## Sol

REV D to E

The following is a complete list of changes necessary to modify a Revision D Sol to a Revision E Sol. These changes are illustrated in Figures A & B for your convenience:

## CHANGE NOTICE #9

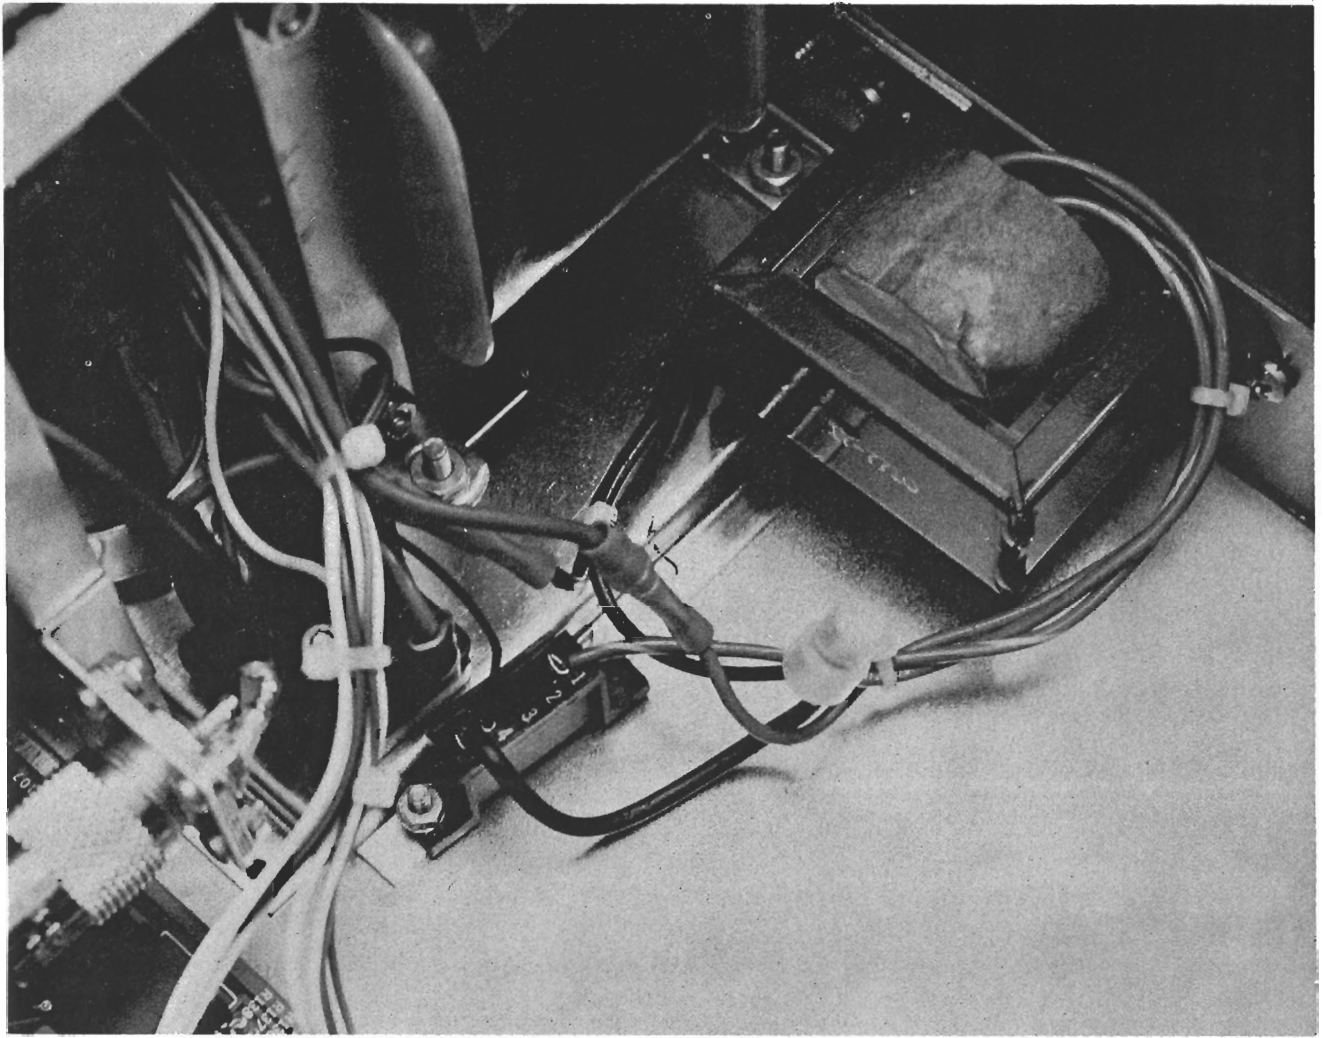
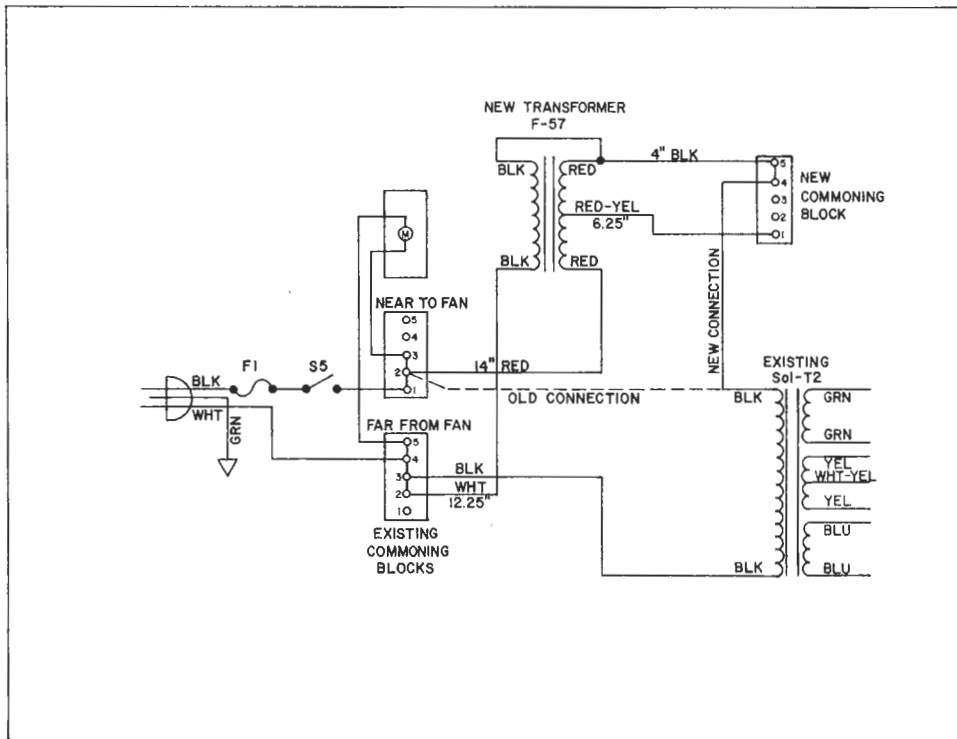
Refer to the Sol Systems Manual, Section X, drawing X-14. The main power transformer, Sol-T2, supplies power for the +8 V dc unregulated supply, which is used by S100 cards plugged into the backplane. Distributed regulators on each S100 card reduce this voltage to +5 volts regulated. Some Sol-T2 transformers supplied with the Sol 20 kits were designed for brown-out conditions; even though the A. C. power line voltage should drop below normal tolerances, these transformers can maintain the unregulated supply so that the +5 volt regulators do not drop out of regulation. Unfortunately, these transformers can provide over +11 volts at a normal line voltage of 120 volts. If the unregulated supply is lightly loaded by boards in the backplane, and the boards in the backplane place heavy demands on their +5 volt regulators, the result can be excessive dissipation in the regulators, activating their normal thermal shut-down circuitry. The power supply circuit can be modified with the addition of a bucking transformer which reduces the effective primary voltage at Sol-T2 by 10 or 20% thus reducing the unregulated supply by 10 or 20% to eliminate the problem. This modification is recommended for all Sols which have the brown-out transformers, if they are used at a line voltage of 110-120 v.a.c. A schematic of the new circuit is shown below.

The transformers can be identified by looking for markings on the laminations of the transformer, on either the top or sides. If the marking "Sol T2" in large letters is found as in the photos below, no modification is necessary. If the marking "4 3991" in small letters is found, make the modification. If any other or no marking is found, contact Processor Technology for further information. If a voltmeter is used to confirm an

CHANGE NOTICE #10

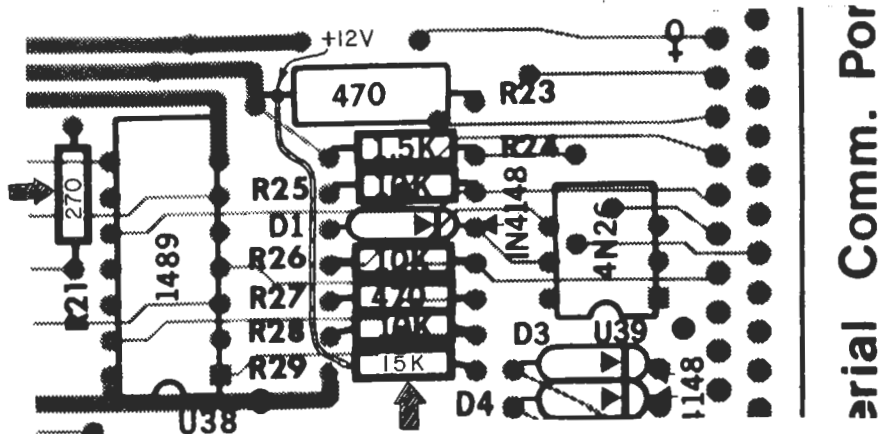
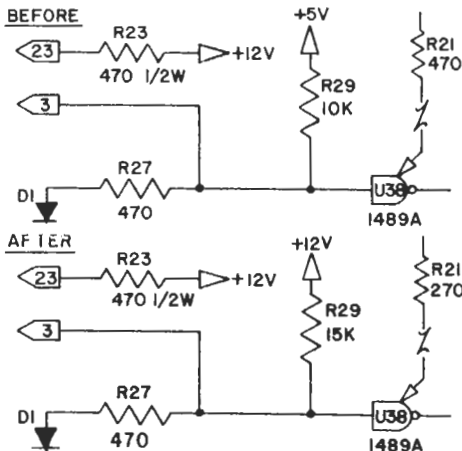
Refer to Section X, Drawing X-17, Serial Data Interface/U.A.R.T. block. The section of U38 which has its input connected to pin 3 of J1 (Serial Loop Current Source) may not have enough drive at its input under worst case conditions, with the present values of R29, the input pull-up resistor, and R21, the resistor connected to pin 12 of U38. Substitute a 15K, 1/4 watt, 5% resistor for R29 (shown as 10K), and a 270 ohm, 1/4 watt, 5% resistor for R21 (shown as 470 ohm). These parts are included in the kit. Note in the schematics below that R29 is to be returned to +12 instead of +5. When R29 is installed, put the .9" length of tubing over the right hand lead. Clip this lead .1" longer than the tubing. With the legend on the P.C. board in normal reading position, hook this lead around the left-hand lead of R 24, a 1.5K resistor, and solder. Inspect the solder joint and lead dress for shorts. An assembly drawing detail of this modification is shown below.

Step	Page No.	Figure No., if any	Changes
1	X-17	Schematic, Input/Output	Change R21 value to 270 ohm
2	X-17	"	Change R29 value to 15K
3	X-17	"	Change R29 return to +12 V
4	X-3	Sol-PC Rev E Assembly	Change R21 value to 270 ohm
5	X-3	"	Change R29 value to 15K
6	X-3	"	Change R29 return to +12 V
7	III-3	Sol-PC Parts List	Add 1 270 ohm 1/4 watt, 5%
8	III-3	"	Change Qty. 470 ohm 1/4 watt to 2
9	III-3	"	Change Qty. 10K ohm to 31
10	III-3	"	Change Qty. 15K ohm to 2
11	III-33	Step 50	Change R21: 270 ohms, red-violet-brown
12	III-33	"	Change R29: 15K ohms, brown-green-orange
13	III-33	"	Under Step 50 instructions add: "See Change Notice #10"

## CHANGE NOTICE #16

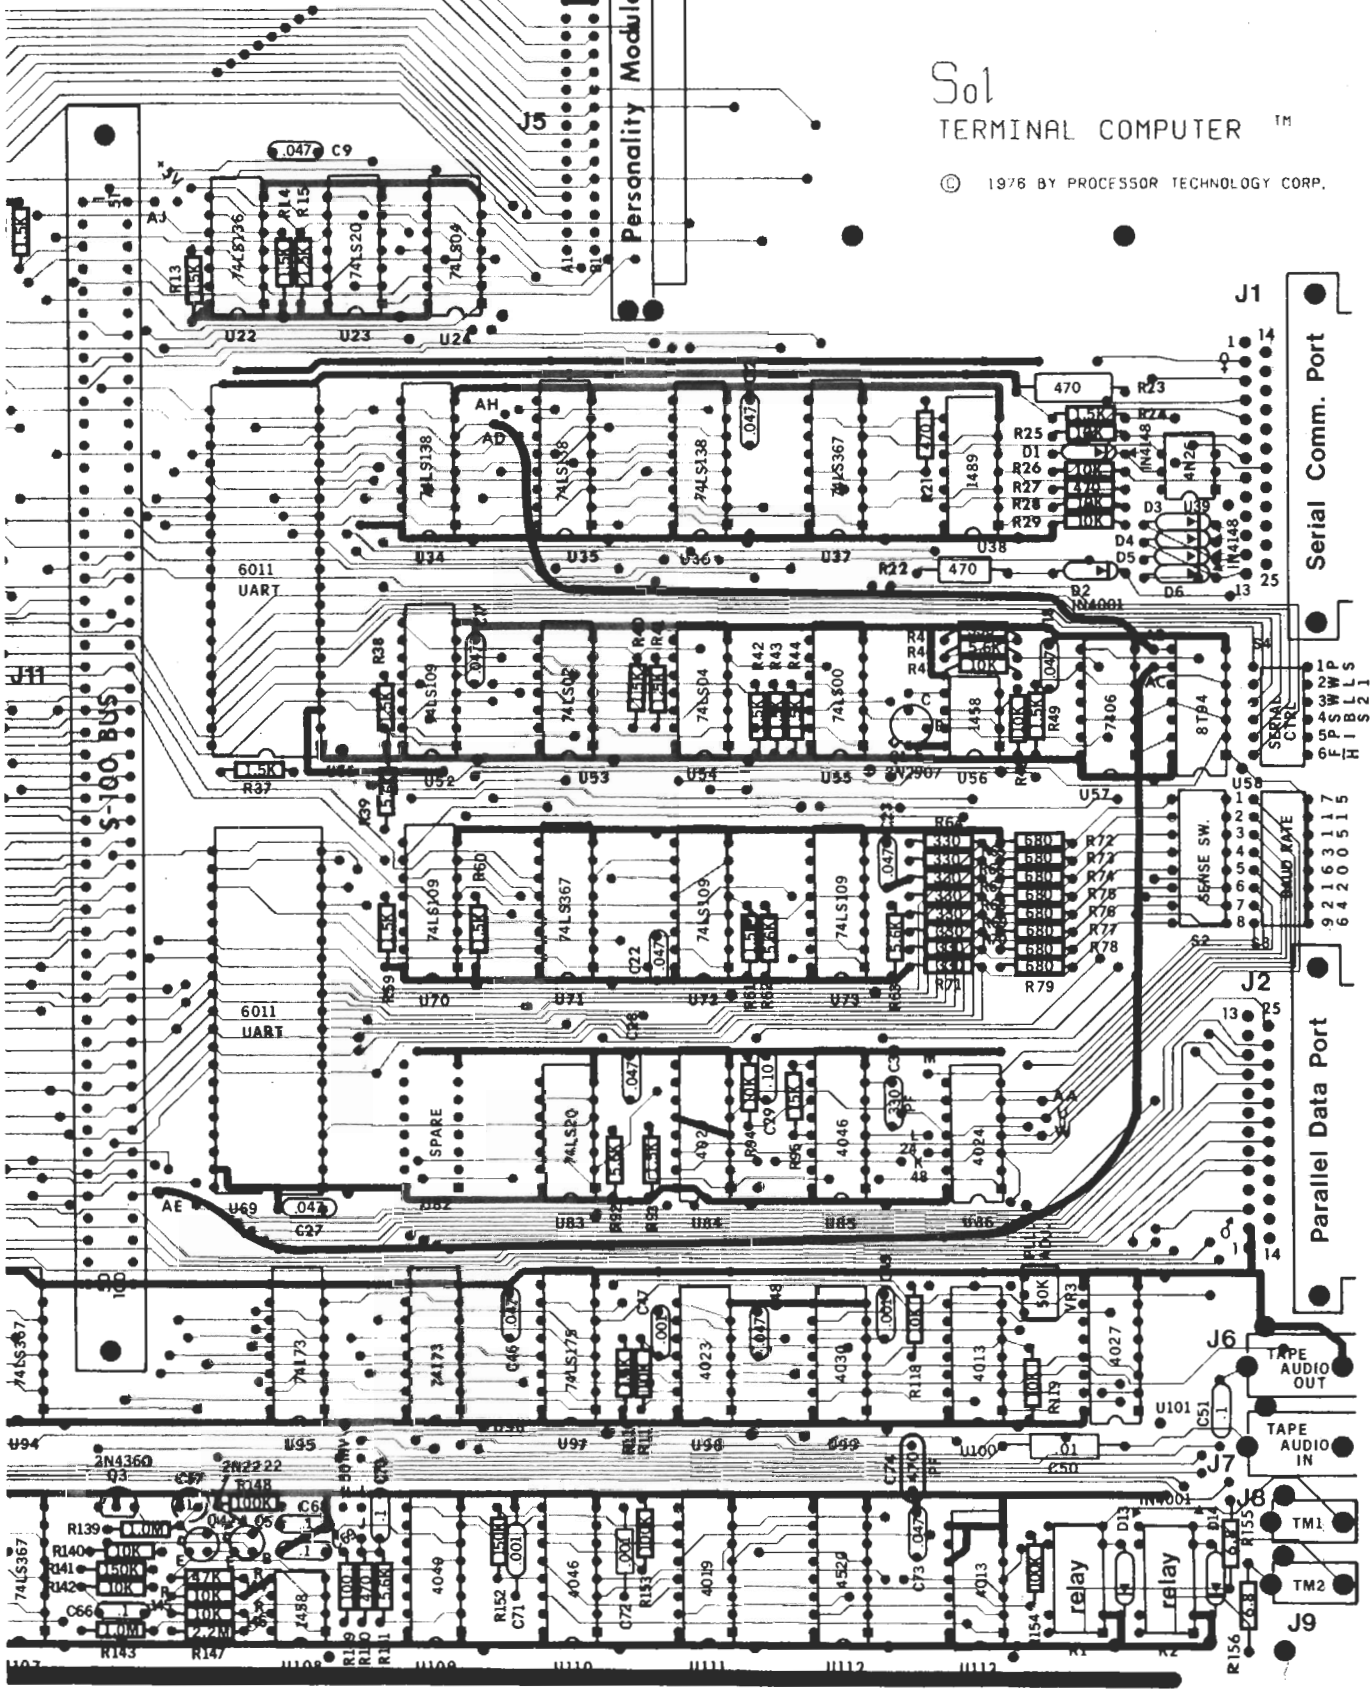
The Sol Computer and other S100 modules built by Processor Technology do not require use of the vectored interrupt capability which the 8080A microprocessor used in the Sol provides. The Sol provides, however, means for implementing vectored interrupt when the interrupt signal is made available by a circuit board inserted in the S100 bus, on S100 bus pin 96, SINTA. If a circuit board in the backplane generates interrupts, two jumpers, shown below, should be added to Sol P.C., to enable the SINTA signal to reach the memory decoder circuit. These jumpers may be added after completing the assembly of Sol-P.C., or even after the Sol is completely assembled and tested. The jumpers should be made from #24 solid, insulated wire (not provided). The electrical effects of these jumpers may be seen on Drawing X-16. These jumpers may be left in place even if no S100 board generates interrupts. S100 bus pin 96 may float with no interference.

- ( ) Step 1. Strip .1" of insulation from one end of each of two eight-inch lengths of wire, and insert into pads AC and AB (near U58) from the component side of the board. Solder and check for solder bridges.
- ( ) Step 2. Dress the wires as shown in the drawing below, trim to length, strip .1" from the loose ends. Insert the wire from pad AB into pad AD, and the wire from pad AC to AE. Solder and inspect for solder bridges.
- ( ) Step 3. Fix the long runs of wire to the board using silicone compound or tape.

Figure A

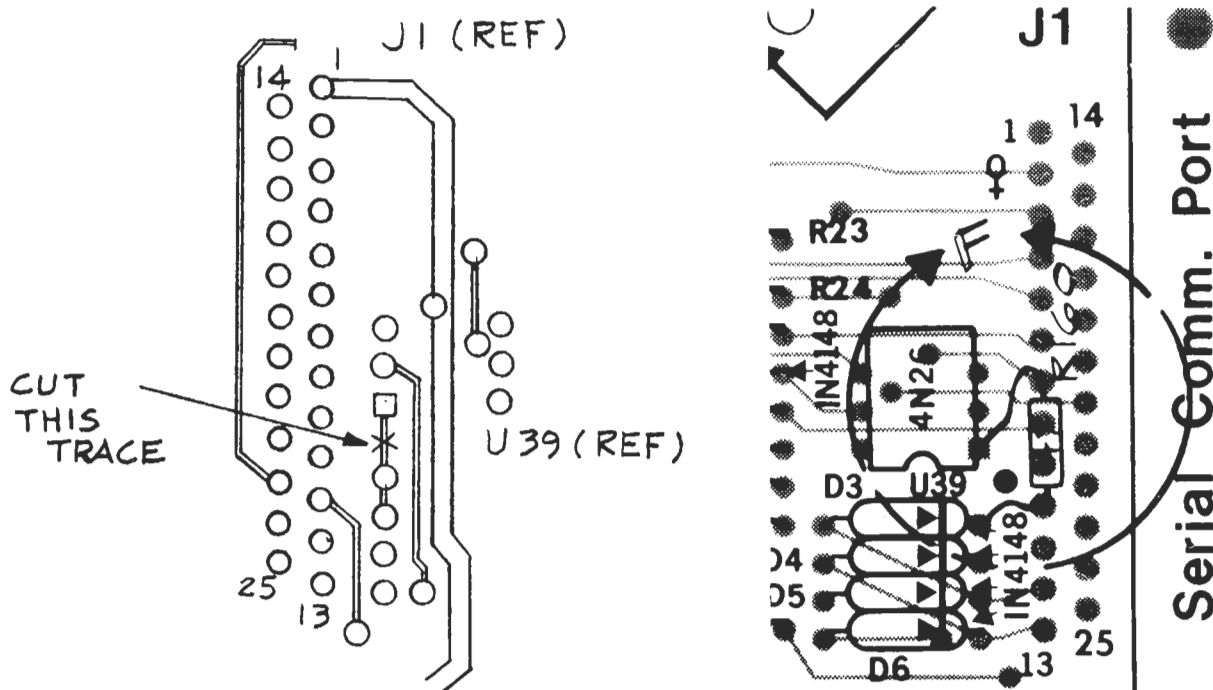
- ( ) Step 4. Install R160 (47 ohm resistor, color code yellow-violet-black) as follows:
  - ( ) Wrap one R160 lead around pin 1 of U39 (4N26) and the other around the cathode lead (banded end) of D3 (1N4148), dressing the leads as shown in Figure A.

- ( ) Solder both R160 leads in place and trim excess lead lengths.
  - ( ) Inspect for possible shorts or solder bridges, especially between pins 1 and 2 of U39.

- ( ) On the back (solder) side of the board, the trace that connects pin 1 of U39 to the cathode lead of D3 must be cut. Using an Xacto knife or a razor blade, make two cuts approximately 1/8" apart, cutting across the trace down to the epoxy base. Insert blade tip beneath the cut section and gently work it away from the board. Be sure the "break" is free of solder.

Figure B

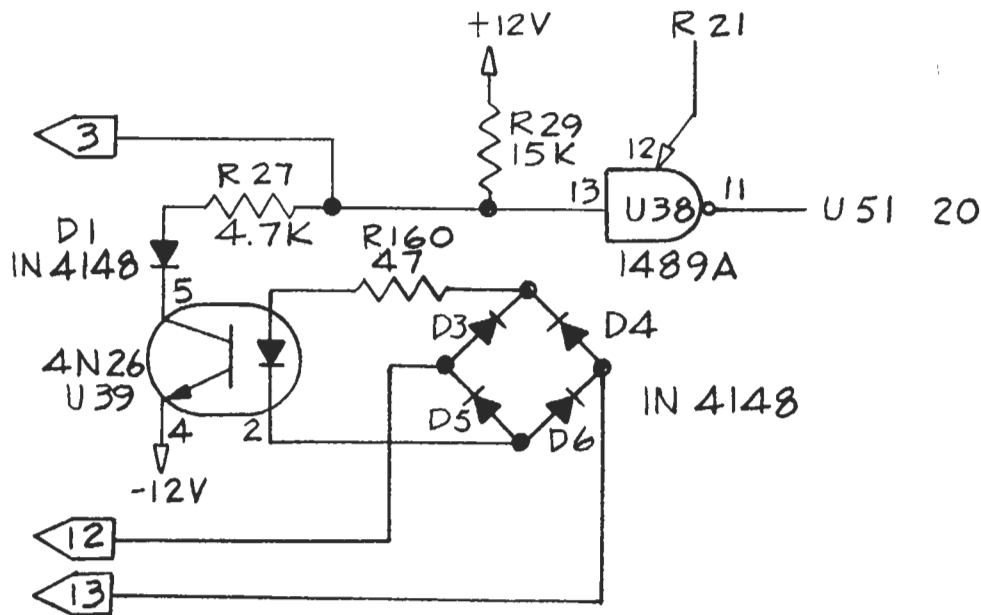
- ( ) Step 5. On Drawing X-17 in Section X, change value of R27 from 470 ohms to 4.7K ohms and add R160 (47 ohm resistor) between pin 1 of U39 and the cathodes of D3 and D4. (Refer to Figure B.)
- ( ) Step 6. Go on to Step 59 in Section III.
